***Appendix K - J03 A335/ Wide Lane – Signal Mitigation Option 2 –
Conceptual Layout and Steer Response to HCC Comments***

Navigator Quarter: Wide Lane Junctions, Eastleigh

Concept Design Check

Steer Responses added in red – 12 December 2025

Network Layout Diagram

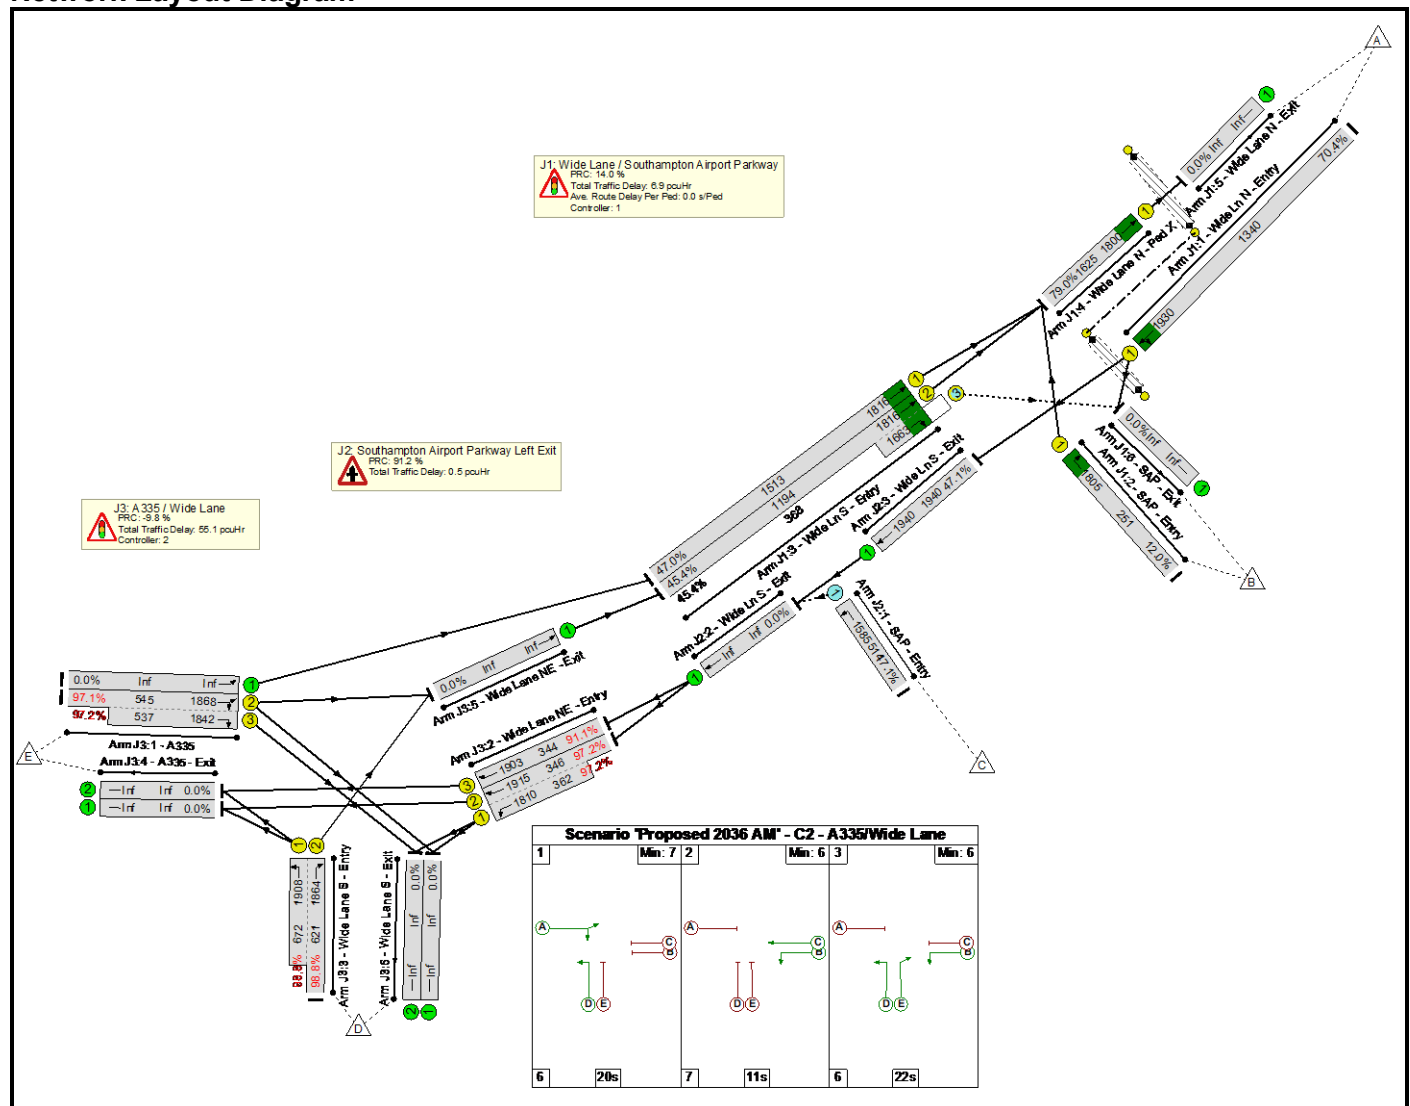
- 17) Within the LinSig model, stages 2 and 3 should be swapped so that phases are not shut down whilst an adjacent phase remains on. This is unsafe and would result in driver confusion.

- 18) The LinSig model includes a 63m offside flare on the A335 approach. However, the plan measures 40m back to the 2.5m dimension. A 3.0m wide lane should be considered as the start of a full lane, the flare length would be significantly less than modelled.

- 19) The LinSig model also includes a 63m flare length for the Wide Lane north nearside lane. The plan measures 40m back to the 2.5m dimension. A 3.0m

wide lane should be considered as the start of a full lane, the flare length would be significantly less than modelled.

- 20) The LinSig model includes a 76m flare length on the Wide Lane approach nearside flare. The plan measures 38m back to the 2.5m dimension. A 3.0m wide lane should be considered as the start of a full lane, the flare length would be significantly less than modelled.

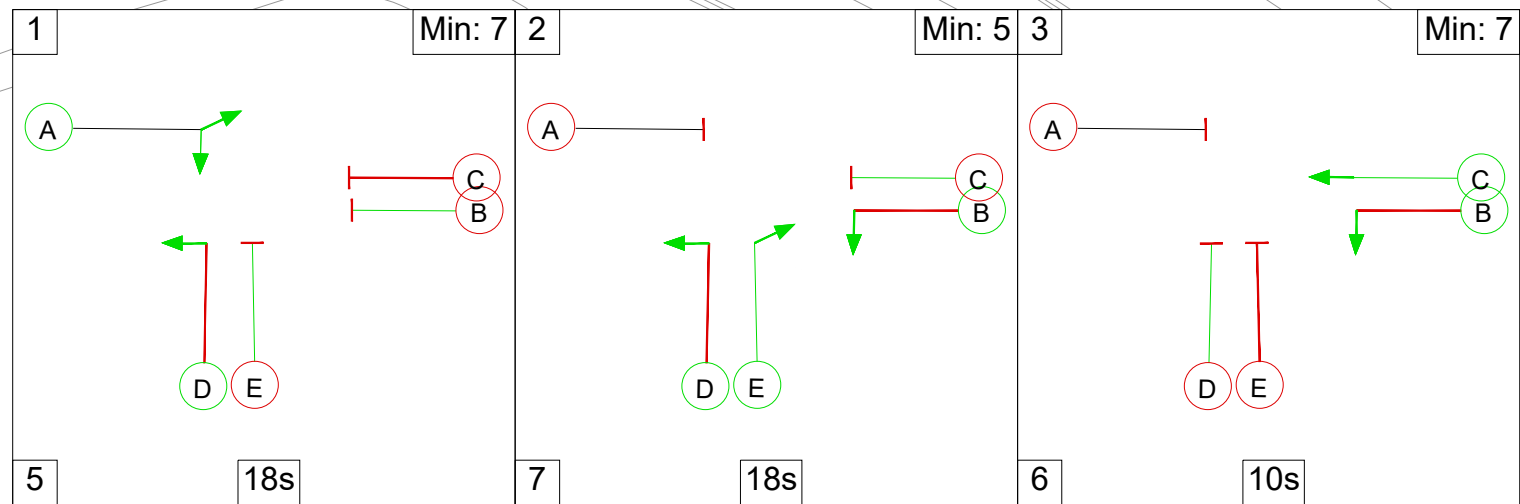
- 17) Within the LinSig model, stages 2 and 3 should be swapped so that phases are not shut down whilst an adjacent phase remains on. This is unsafe and would result in driver confusion.

- Noted – this has been addressed in latest LinSig model. Updated signal staging diagram shown on the drawing.

24733101-STR-HGN-100-SK-D-01201

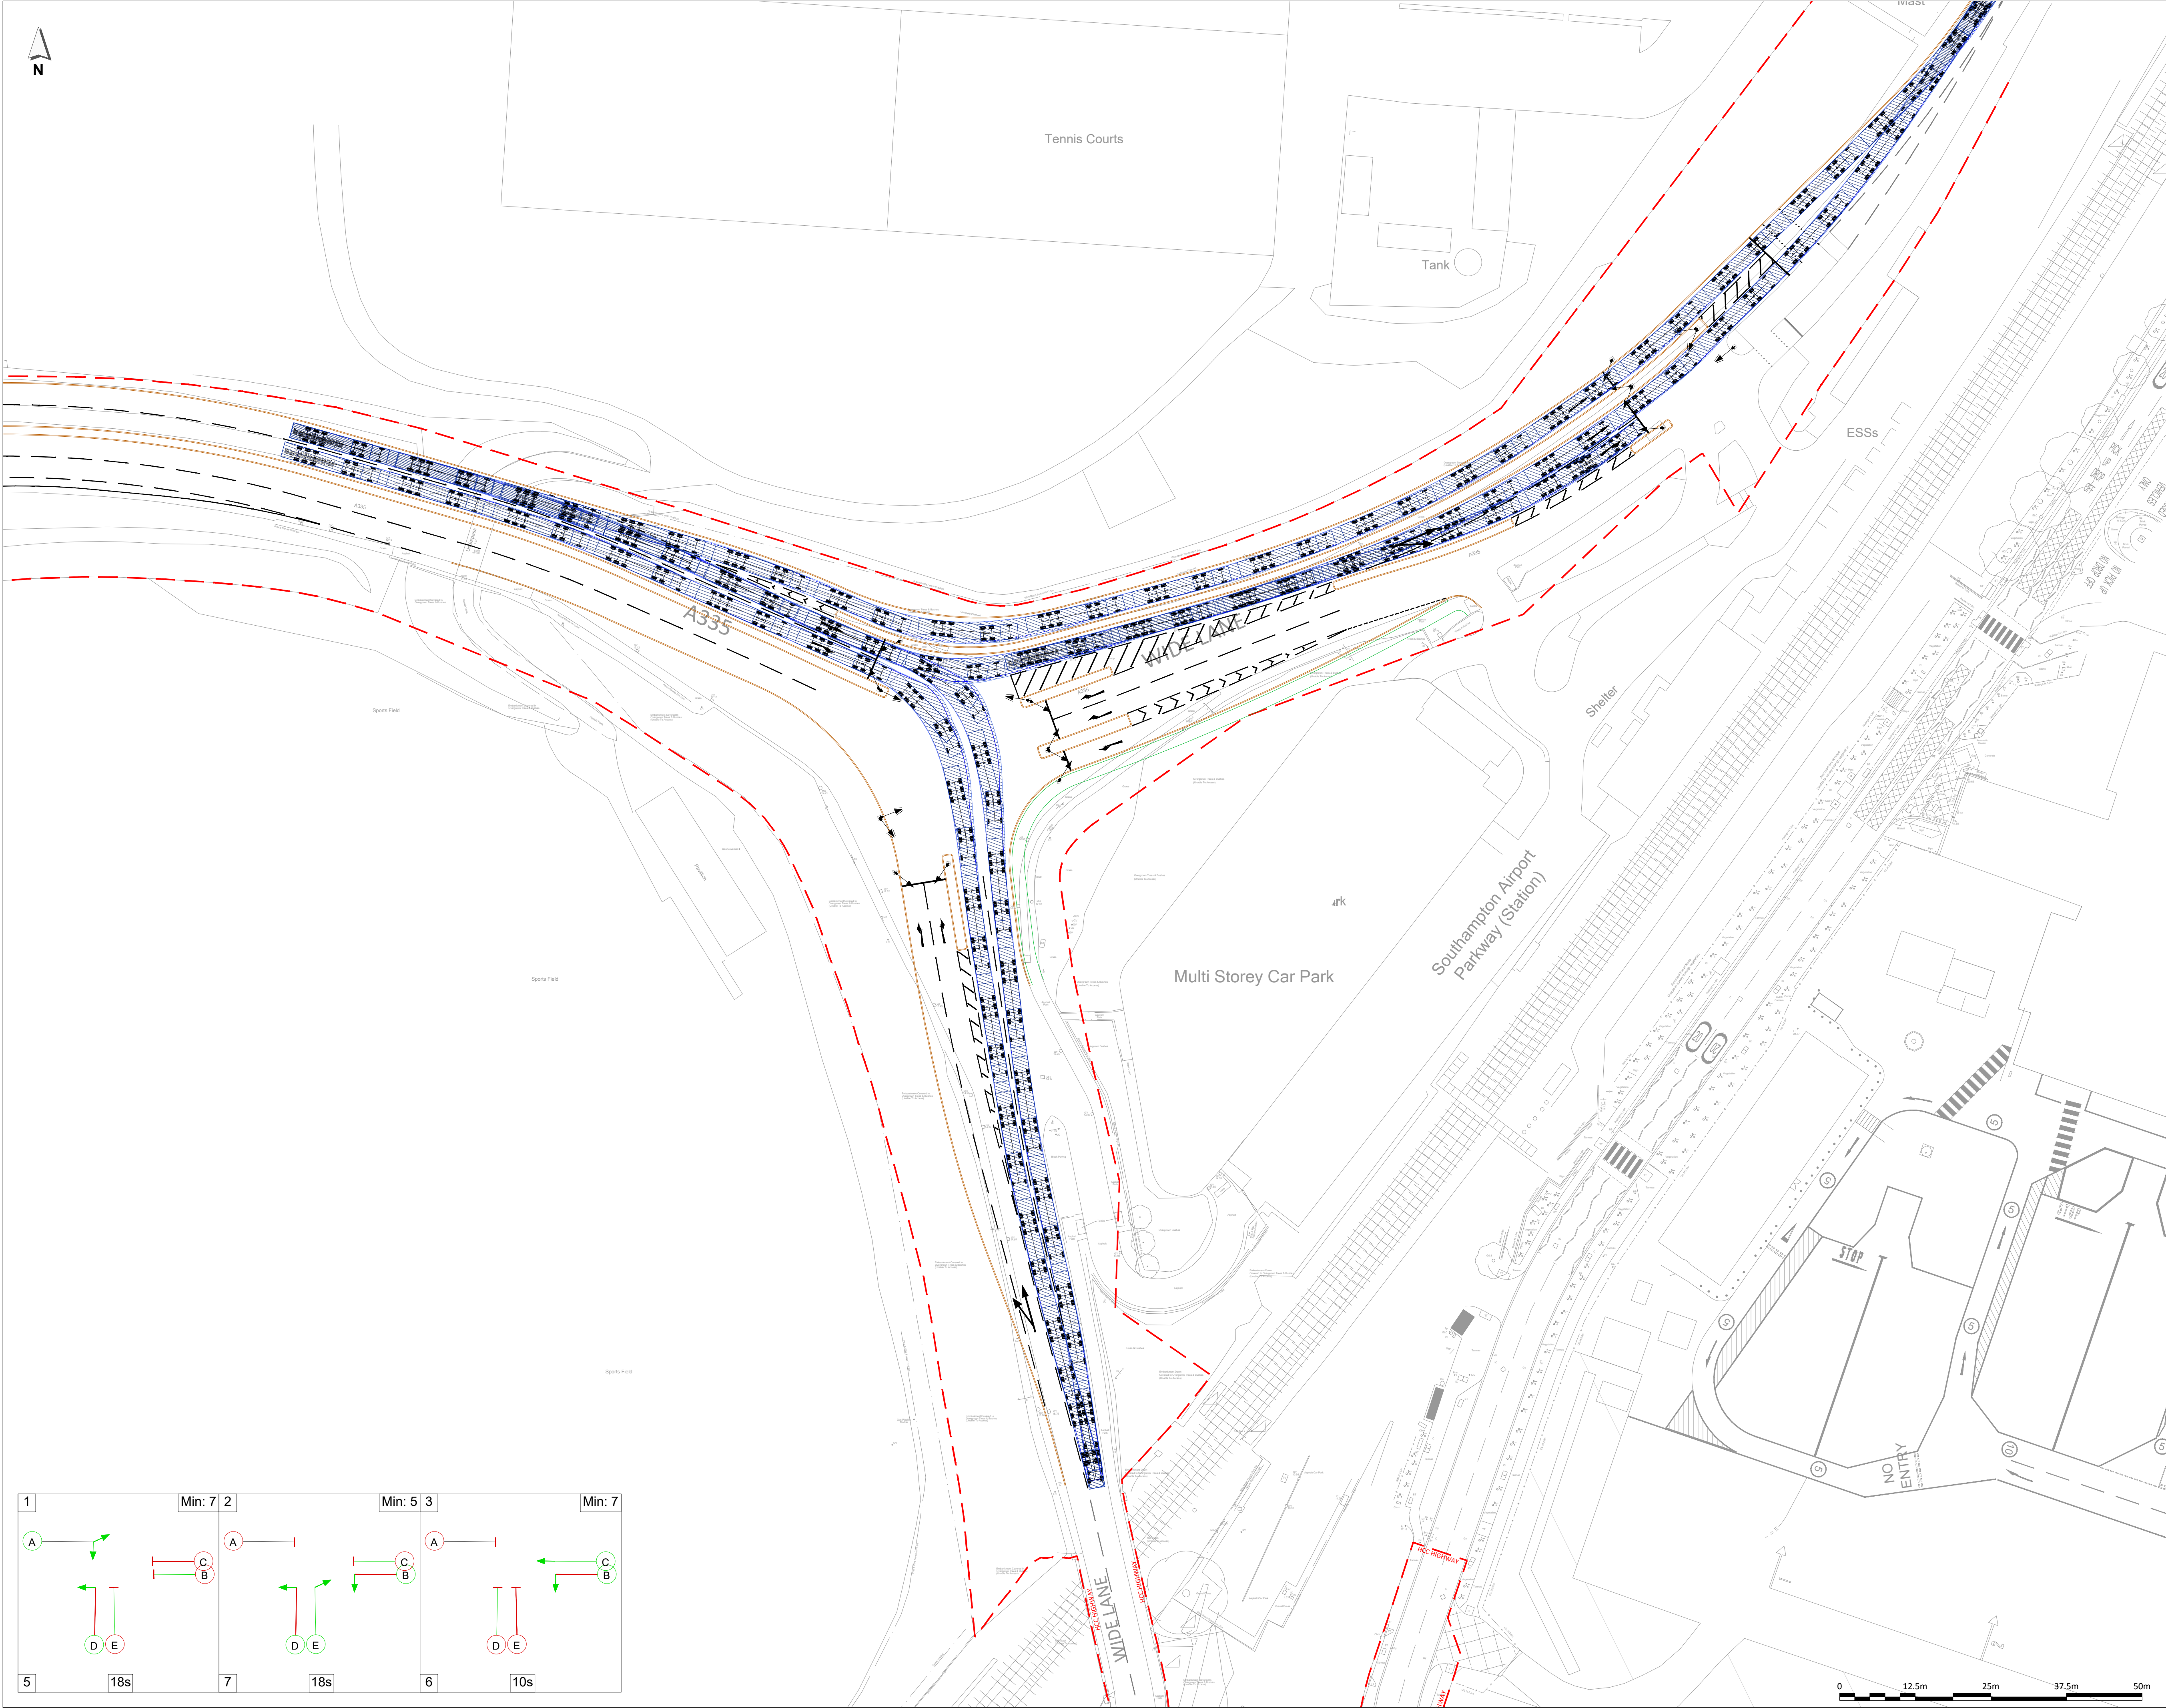
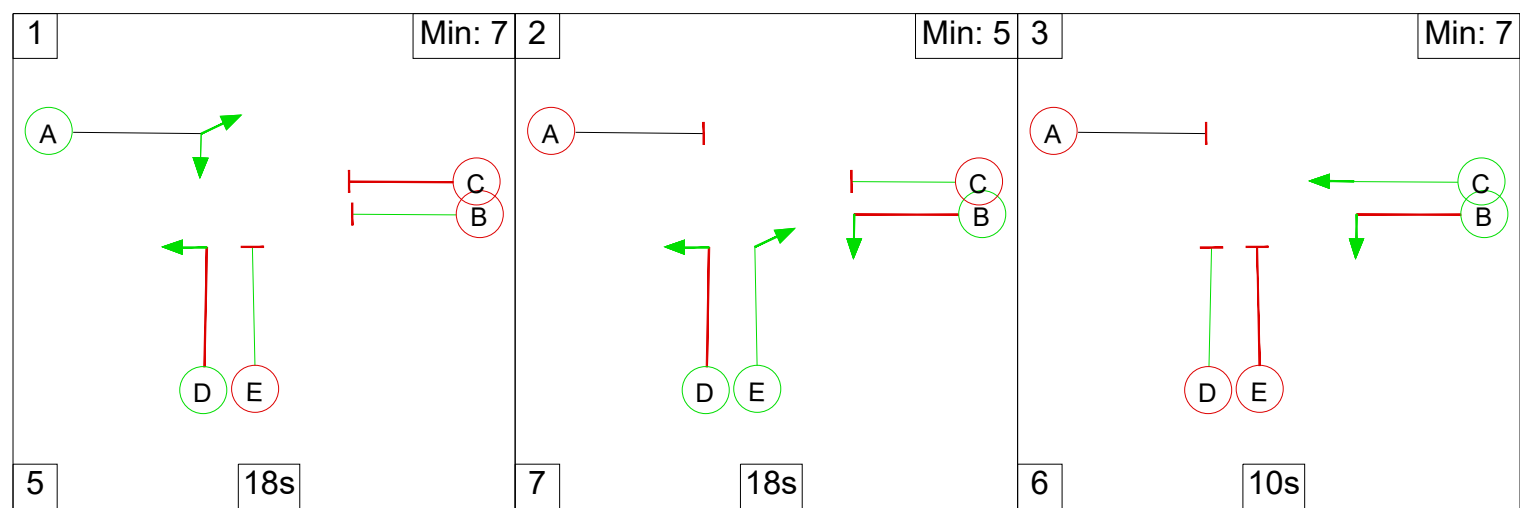
The proposed design (drawing 24733101-STR-HGN-100-SK-D-01201 rev P0) contains a series of fundamental safety and operational concerns. The 'Y' junction design concept would not be acceptable. Below are the most significant issues identified at the concept design stage.

- 5) Concern exists that the two lanes turning right from Wide Lane and the two lanes turning right from the A335 will be unsafe and result in side-swipe collisions. The right turn from the A335 is of particular concern, as traffic in the nearside lane must turn past the exit and then turn back to avoid a conflict. This is an unnatural turning movement and is likely to see side impact collisions. While the issue could be addressed to some extent through the use of the road markings, such markings would be tracked over by turning vehicles and quickly deteriorate. This would leave the County Council with a costly maintenance burden and an ongoing safety issue.

- 6) The design uses 3.65m lanes, which are excessive given the circumstances and lane widths between 3.2m and 3.5m would be acceptable.
 - Noted – 3.65m lane widths were used as the standard lane width, however these have been reduced in places, in conjunction with addressing the other comments.

- 7) The design includes a flare on the A335 approach and merge on the A335 exit. It would be beneficial for both safety and capacity to dual in both directions all the way to the motorway junction. This may require a structure to extend the highway over the playing fields track.

- 8) The A335 eastbound diverge and westbound merge happen at the same location. Given the geometry and lack of physical separation, there is concern that this could lead to head-on collisions.

- See response to 7 above, dualling and continuous central reserve addresses this comment.
- 9) The segregated left turn lane from A335 to Wide Lane north is shown as 4m wide. This will need to be wide enough to accommodate a broken-down vehicle and still allow a 16.5m artic to pass. This will result in a much wider lane width. An alternative would be to remove much of the separation island and replace it with a hatched area that vehicles may enter should one break down. However, this would introduce the risk of drivers from the segregated lane overrunning the hatched area to cut across the adjacent lane in an attempt to turn right into Parkway Station.

- 10) Drivers from the A335 headed to Parkway Station may use the segregated lane to bypass the signals and then find themselves unable to access Parkway Station at the junction. Signing would be insufficient to avoid this. This could lead to drivers attempting to turn right from the segregated lane at the Parkway junction.

- 11) The footpath shown at the pinch point on the Wide Lane northern approach is only 1.2m wide. The footway width should be 2m minimum throughout.
- The kerb line has been realigned by narrowing the westbound lanes to 3.35m each, providing space for a 2.0m wide footway with 0.5m buffer to the road, within the highway boundary.

- 12) The exit lane on Wide Lane north is 3.65m wide between kerbs. Although the section is relatively short it may need to be widened to accommodate a broken down vehicle to pass.

- 13) The merge on the Wide Lane south exit is substandard at circa 40m, which will require a departure from standard which is unlikely to be supported. It should be noted that with a short merge distance very few drivers would be likely to use A335 nearside lane to turn right. This is further compounded by the unconventional right turn movement from the nearside lane. As shown on the layout the A335 to Wide Lane south movement is effectively a single lane for modelling purposes.

- The alignment has been adjusted slightly as a result of other changes made, however the overall junction alignment is dictated by the orientation of the existing approach roads. Swept paths are shown for 16.5m artic vehicles which show the proposed layout can be navigated.

- Dualling added between Wide Lane junction and motorway roundabout junction.

- This has been left as-is, however refer to comment 12 which we have addressed by widening to provide space if a vehicle is broken down. This seems the pragmatic approach – if a vehicle were to break down in the segregated left turn lane, then that lane could be closed and all traffic could still proceed to the junction to turn left via the nearside lane instead.

- Segregated left turn lane/island has been extended through the junction and the widening extended accordingly to the north of the junction, such that drivers in this lane cannot attempt to turn right at this junction.

- This exit has been widened to provide width for a 16.5m artic to pass a broken down vehicle. Standard lane width shown with the “excess width” hatched out.

- Carriageway widening is now shown on the west side of Wide Lane south to extend the 2-lane southbound exit from the junction as far south as possible, before merging into 1-lane at the railway bridge. This

results in a length of approximately 75m on exit from the junction before merging into 1-lane.

- See response to comment 13 where the merge has been extended further south as far as is feasible, which takes the merge south of the car park access.

- See response to comment 10 where the segregated left lane/island has been extended further east through the junction.
